**Manatee County Solid Waste Management Facility
Lena Road Class I Landfill
3333 Lena Road, Bradenton, Florida 34211**

**APPLICATION AND ENGINEERING REPORT FOR
RENEWAL OF THE CLASS I LANDFILL
OPERATION PERMIT**

RE: Lena Road Class I Landfill Operation Permit Renewal
Pending Permit No.: 39884-018-SO/01, Manatee County
WACS ID No.: SWD-41-44795

TASK
**WATER QUALITY AND ELEVATION
MONITORING NETWORK**

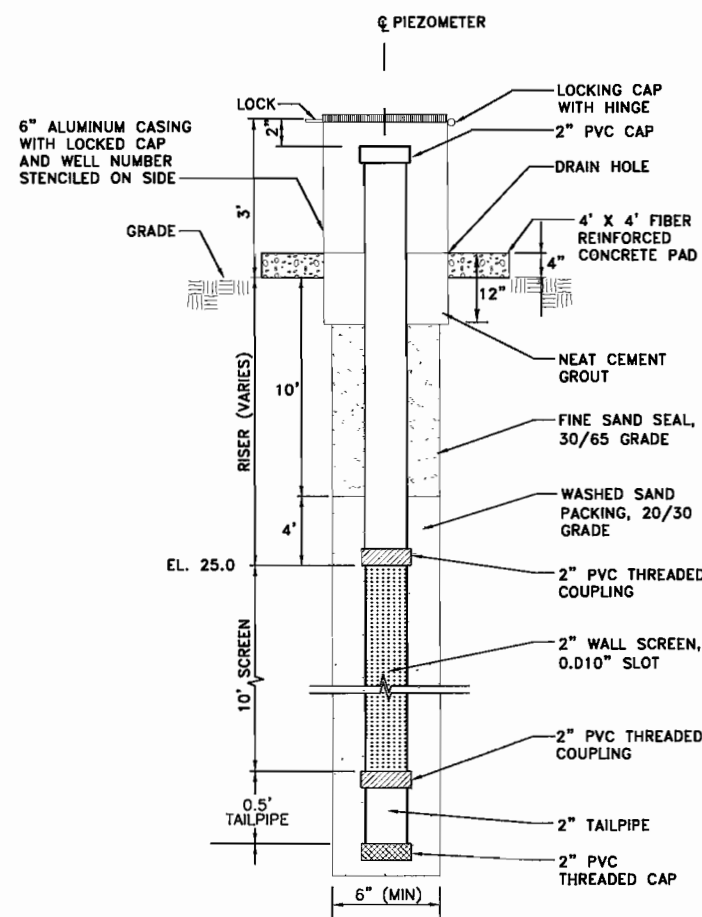
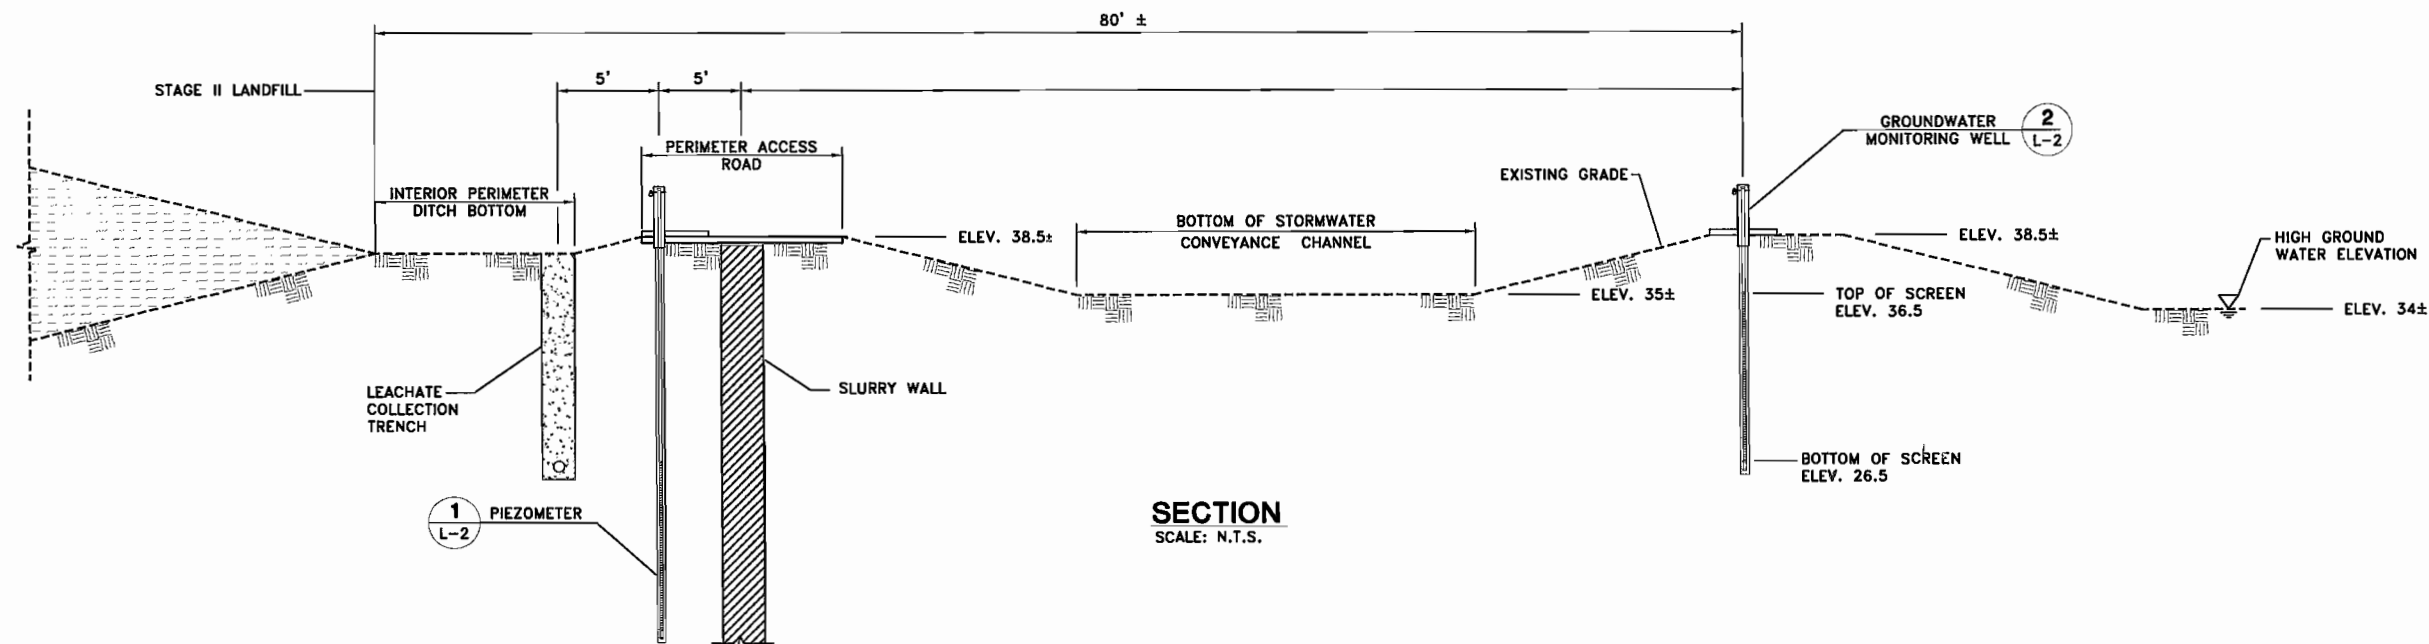
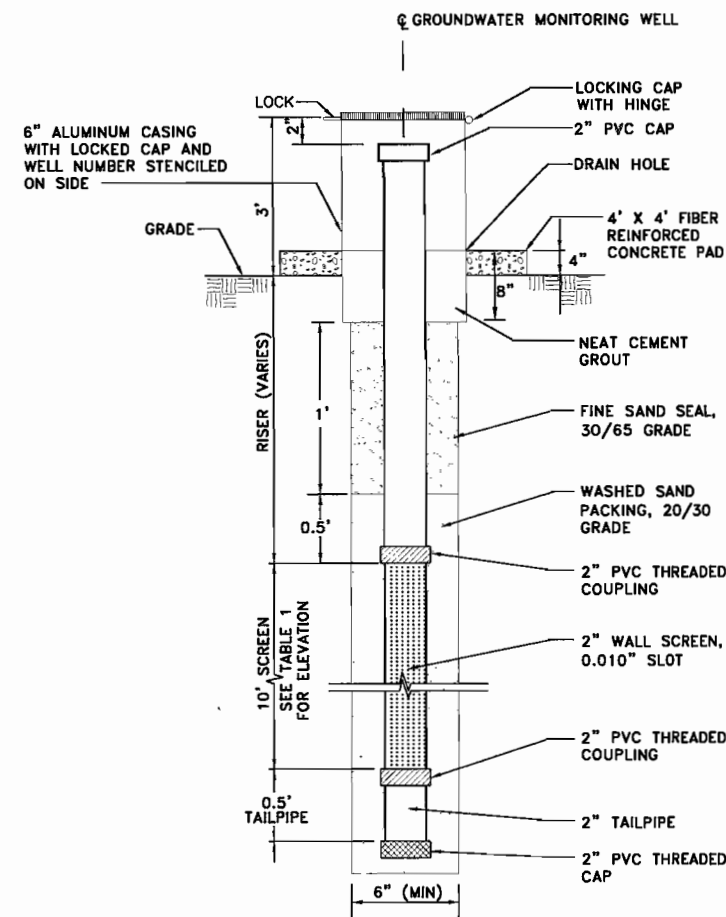
7. **M.1.c.(6): Well screen locations properly selected** [Rule 62-701.510(3)(d)4, F.A.C.] This item of the application form referenced Section M.1.c., of the Engineering Report. Inset Table 1 on Figure M-2 provided the range of screen elevations for proposed wells GW-18 through GW-28 [each well screened at 25 to 40 feet NGVD]. This proposed well screen elevation range is qualified by a note that indicated the elevations may change depending on water table elevation at the time of well installation. This note does not demonstrate that sufficient information has been collected to characterize seasonal variations in ground water elevations in the vicinity of Stage II [refer to Rule 62-701.410(1)(a)1, F.A.C.] to meet the technical justification of construction details for proposed monitor well to meet the requirements of this item. Please submit revisions to this section of the Engineering Report and to Figure M-2 as needed to support the construction details of the proposed monitor wells.

Response: Figure L-2 was revised to show the location for the groundwater monitoring wells. The wells will be placed on the top of the perimeter stormwater dike. The top of screen will be set at El. 36.5 which is approximately 1.5 feet above the invert of the stormwater swale. So the top of screen should be above the groundwater level. The invert of the screen is set at El. 26.5 which should be low enough such that the ground water level will not drop below the invert of the screen.
